SAFETY RECALL BULLETIN

NHTSA RECALL 21V150

AUTOCAR, LLC SAFETY RECALL DC-2103

This document provides work instructions for the relocating and securing the head lamp/windshield wiper wiring harness.

Figure 2

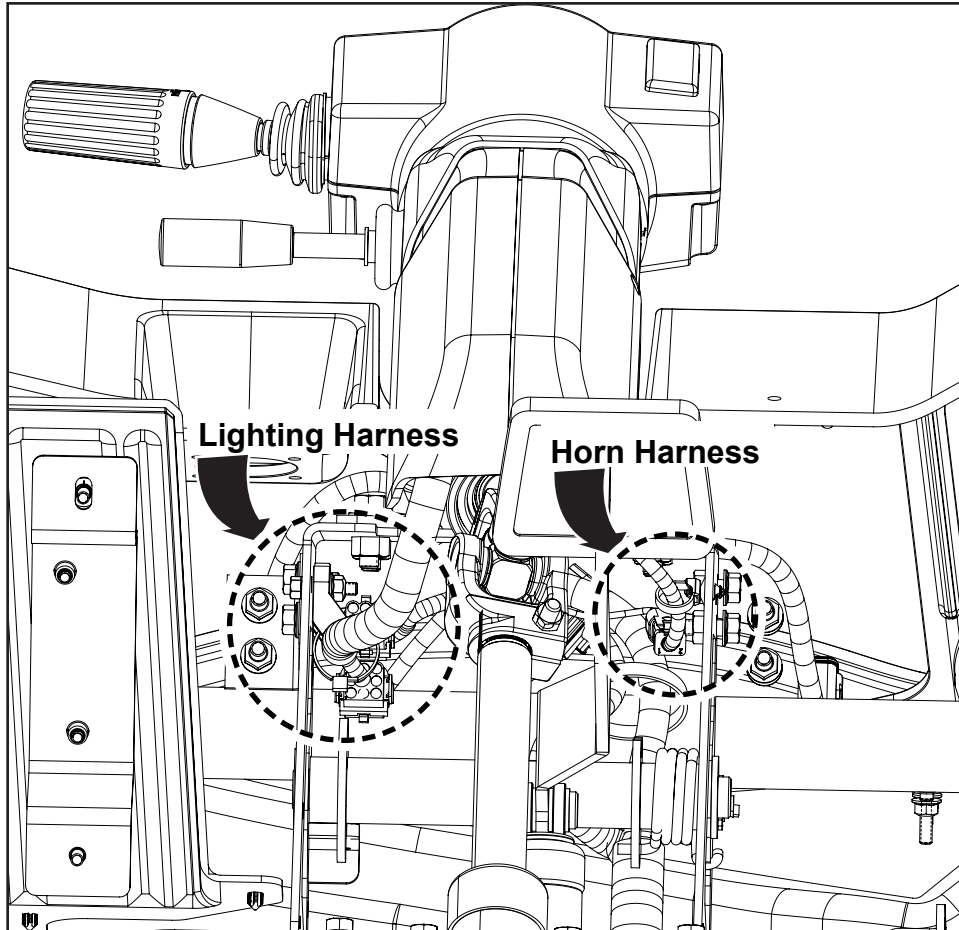
4. Verify the head lamp harness and horn harness are secured correctly, and are routed clear of the steering column yoke. The mounting holes for securing harnesses already exist. If not installed as shown, proceed to step 5 (see *Figures 2, 3 and 4*).

Figure 3

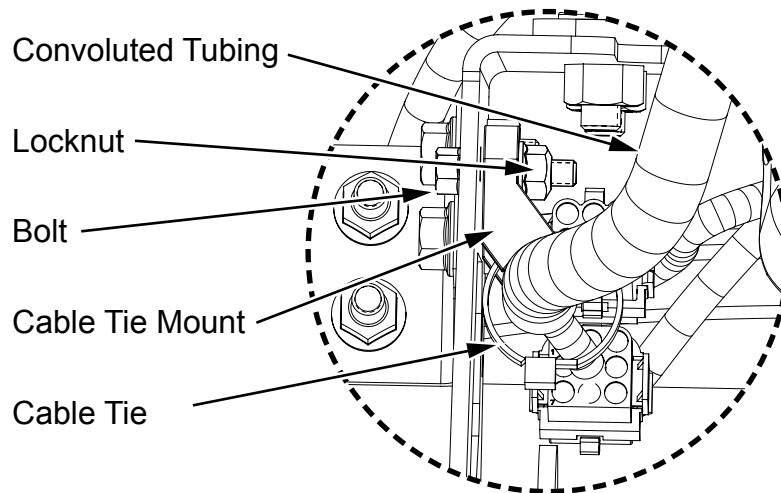
- 5. HEAD LAMP HARNESS DETAIL:** Install (1) 8397612 convoluted tubing, (1) FE286225BW01 locknut, (1) FE410125AW12 bolt, (1) GZ220044-001 cable tie mount, and (1) 948210 cable tie (see *Figure 3*).

Figure 4

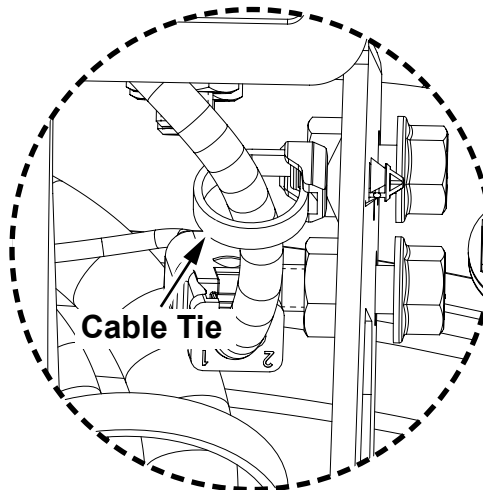
- 6. HORN HARNESS DETAIL:** Install (1) 948210 cable tie (see *Figure 4*).
